## **Wheeler River Project**

Indigenous Engagement  
Appendix B Part 4

**Denison's Responses to Comment from Ya'Thi Néné Lands and Resource Office (March 4, 2023) for the Wheeler River Project Environmental Impact Statement**

attachment: YNLR's July 2023 Cumulative Effects Study Area with Suitable Caribou Habitat with Industrial Disturbance (500m)

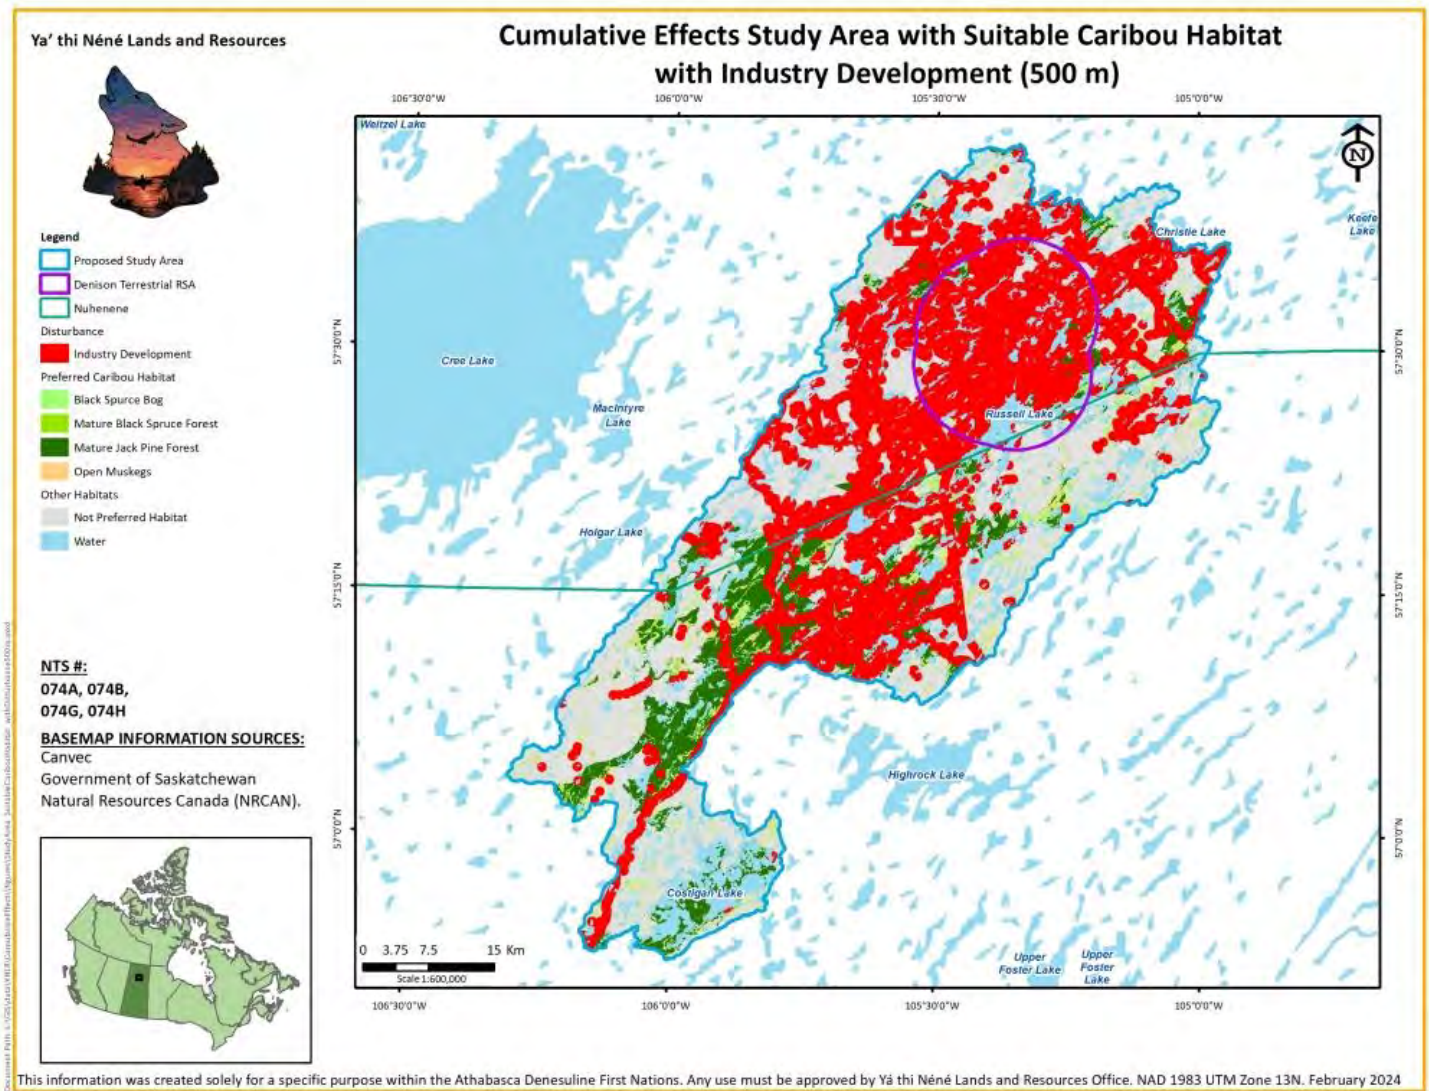
YNLR's conclusion differs from Denison's EIS regarding the environmental impacts to woodland caribou habitat and the level of cumulative effects (CE) currently existing in the Wheeler River watershed (that encompasses the Regional Study Area addressed in the EIS). This position is based on YNLR's own CE analysis of this watershed (see Appendix 1). The methodology used in this analysis is derived from the Federal Woodland Caribou Recovery Plan (2020), which has been accepted and endorsed by both provincial and federal governments. In further substantiation of the Federal Plan and its guidance;

It is YNLR's position that our CE analysis is a reliable representation of the current caribou habitat status in the Wheeler River watershed. Simply stated, the level of human and natural disturbance in the watershed already exceeds the federal caribou conservation guidelines, and therefore any additional disturbance from Denison's project should be deemed 'significant'. We therefore believe that the way forward for Denison and YNLR is a discussion on caribou mitigation and offset plans and we look forward to discussing this topic at our 22 February meeting.
